BULLETIN #159

SYNCHRO-PULSE CDT 450

FLICKERING BAR GRAPH DISPLAY

Example:

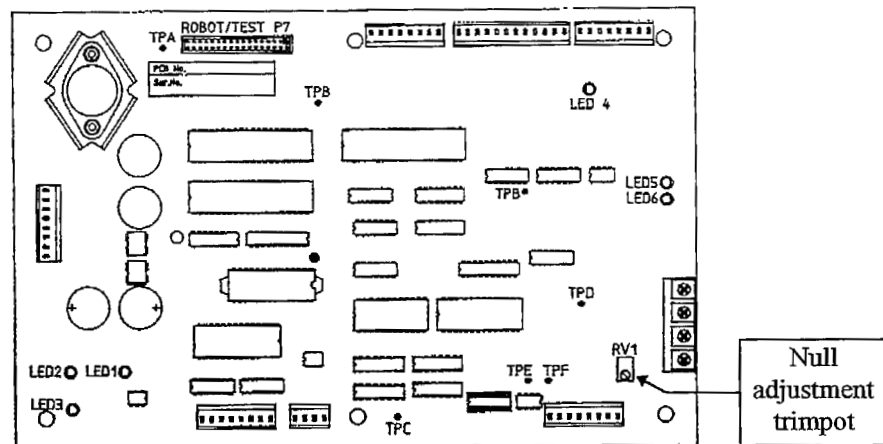
There have recently been a number of cases where the CDT 450 in its idle state has gone from its "ready" state display to a flickering "bar graph" display.

The source of this problem has been traced to a bad batch of grey coloured, 10K trimpots used as null adjustment calibration for the CP38-10 microprocessor boards. This particular batch of trimpots would cause the null adjustment to drift significantly (approx. 100mV) over a period of 8 weeks, resulting in the bar graph display. Further drift of the null adjustment would cause the bar graph to flicker.

A blue coloured, 10K Bourns brand trimpot has been sourced and trialed successfully and will now be fitted to all production CDT 450s.

Anyone encountering this problem should replace the grey coloured trimpot with the new Bourns brand trimpot. WIA part number for this trimpot is CP38-10/12. Refer to the diagram below for the null adjustment trimpot position. Also, refer to Service Bulletin #156 for the null calibration procedure.
